Title: *aLIGO OMC Low Voltage Piezo Drive*			Last Edited: *20 May, 2013*
Size: C	DCC Number: D1300024	SCH / PCB Revision: v3	Engineer: *R.S. Abbott*
File: C:\Users\dschaetz\Desktop\LVPiezo_v3 (2-22-2019)\LV Piezo Drive v3\LVPiezo_v3.SchDoc			Date: 2/22/2019
			Time: 12:29:55 PM
			Sheet 1 of 1

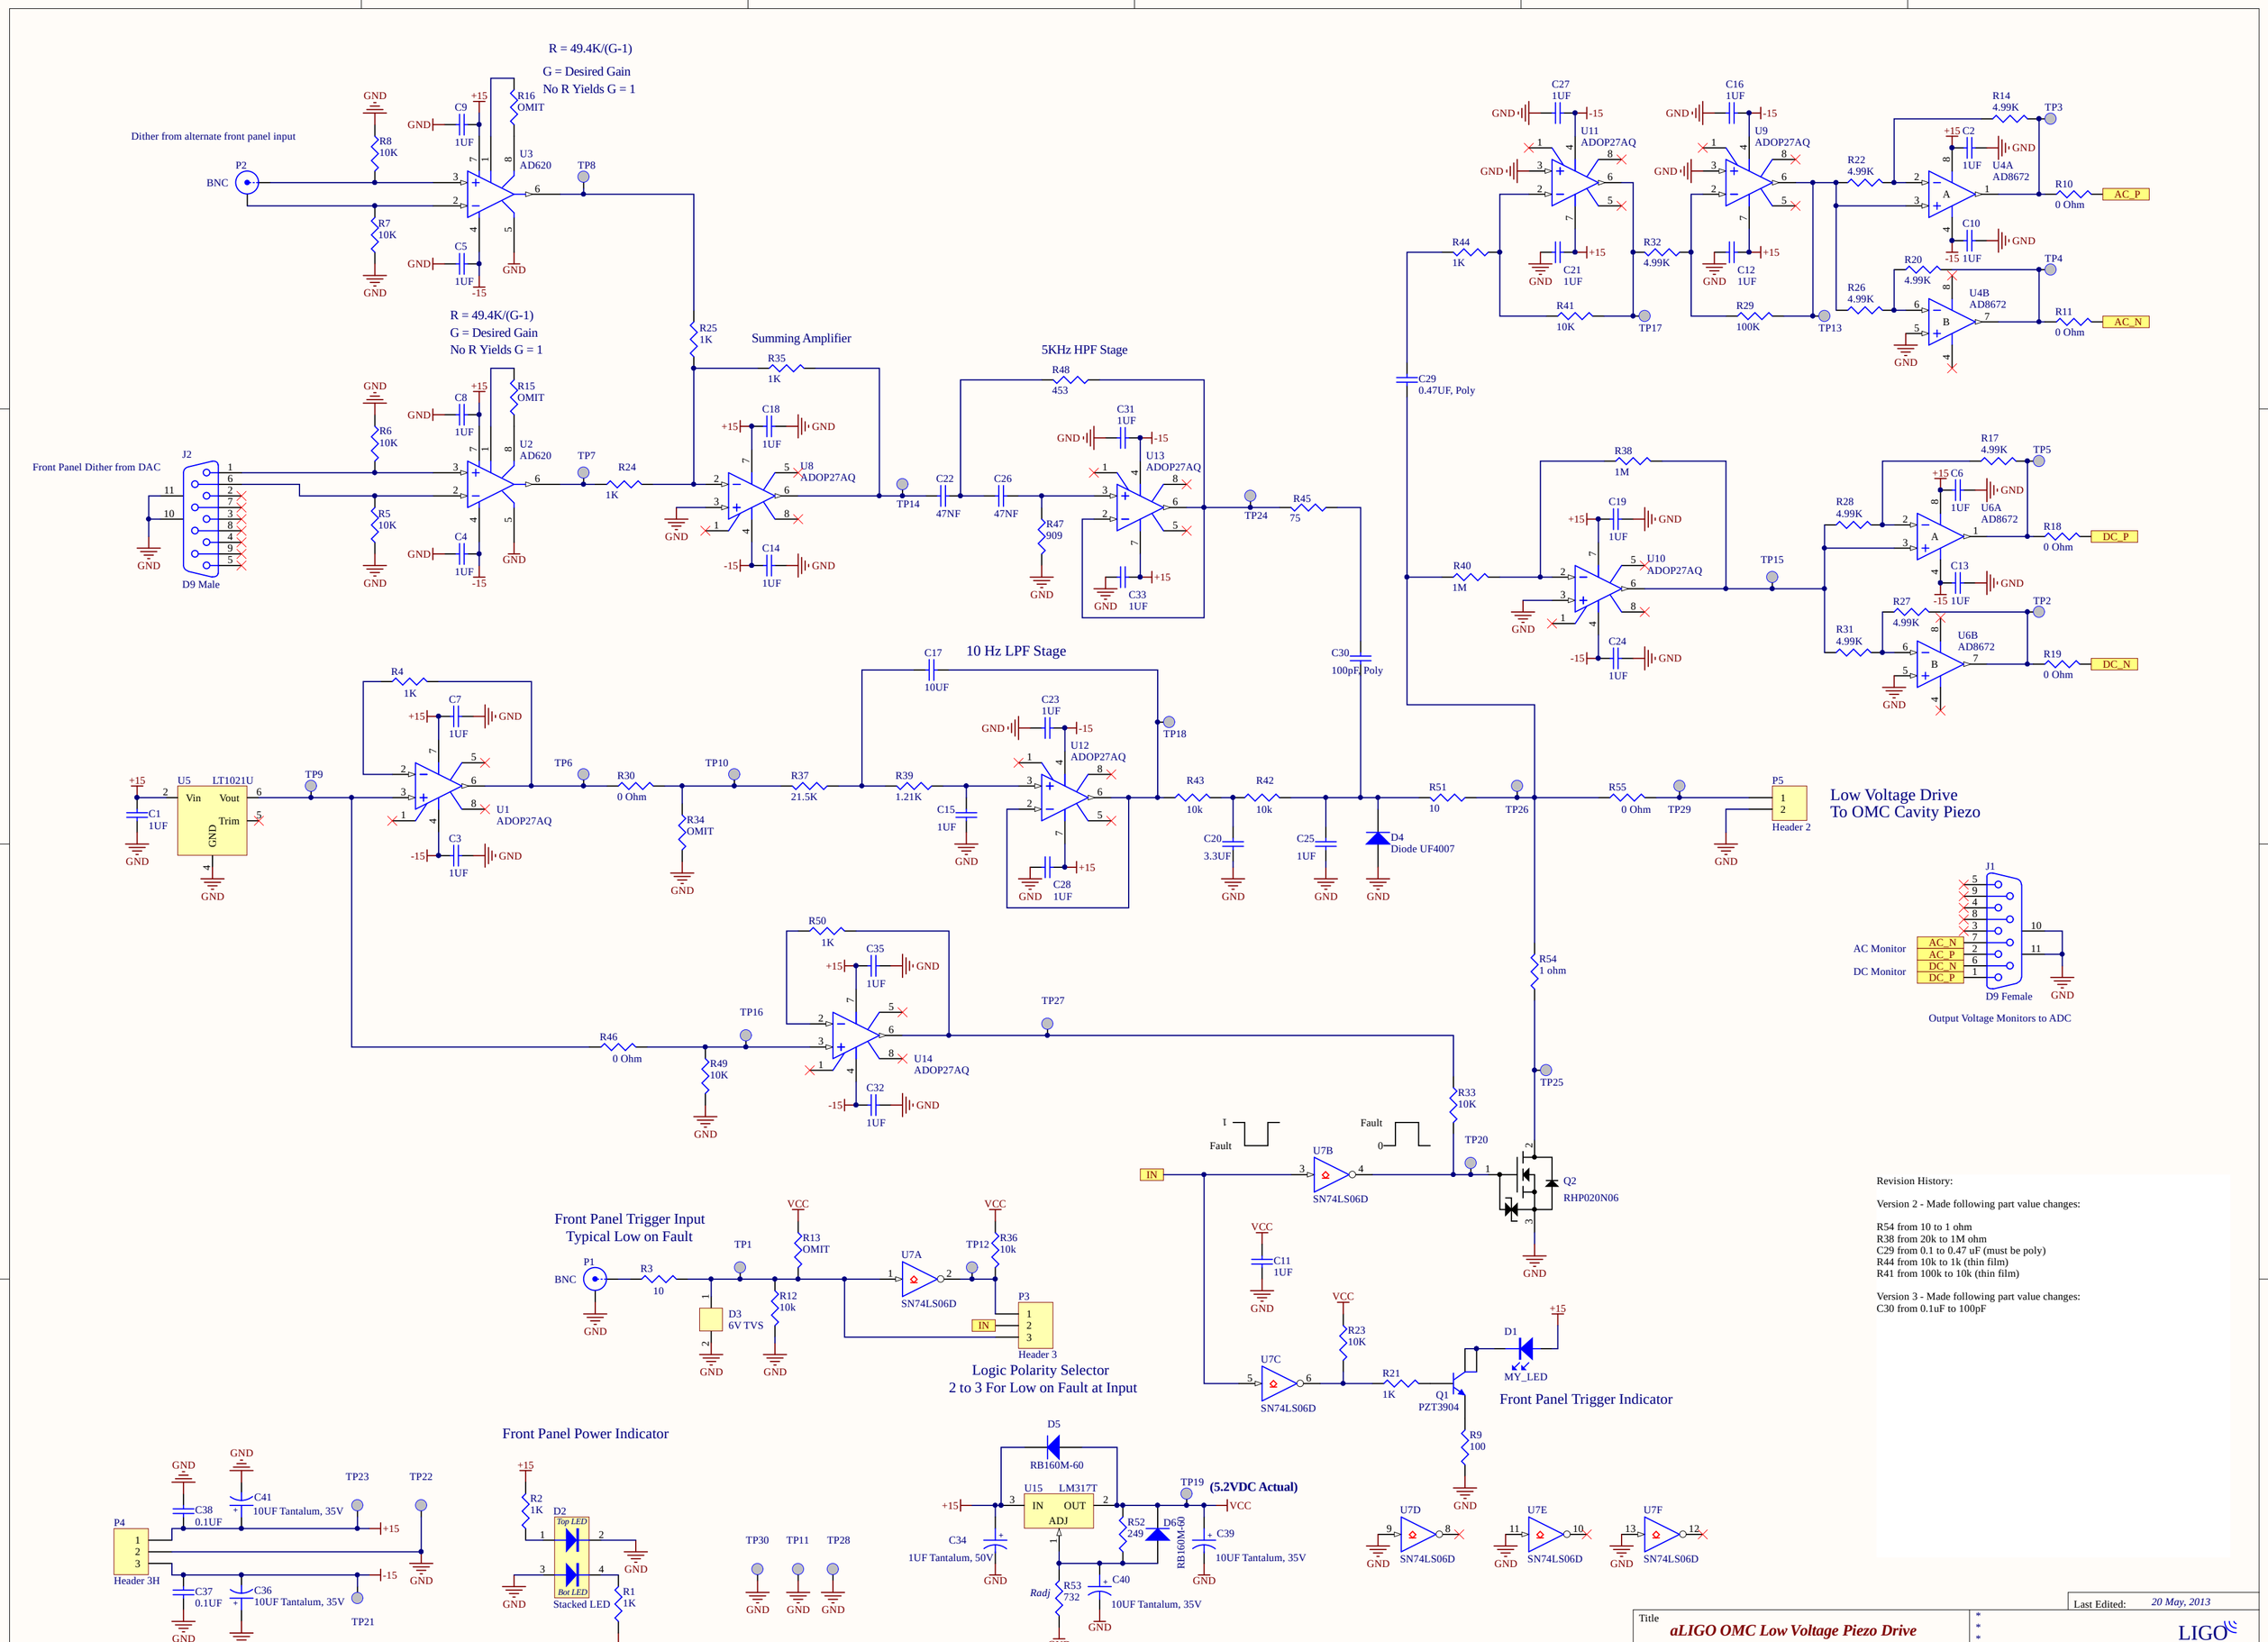
Version 2 - Made following part value changes:

R54 from 10 to 1 ohm
R38 from 20k to 1M ohm
C29 from 0.1 to 0.47 uF (must be poly)
R44 from 10k to 1k (thin film)
R41 from 100k to 10k (thin film)

Version 3 - Made following part value changes:
C30 from 0.1uF to 100pF
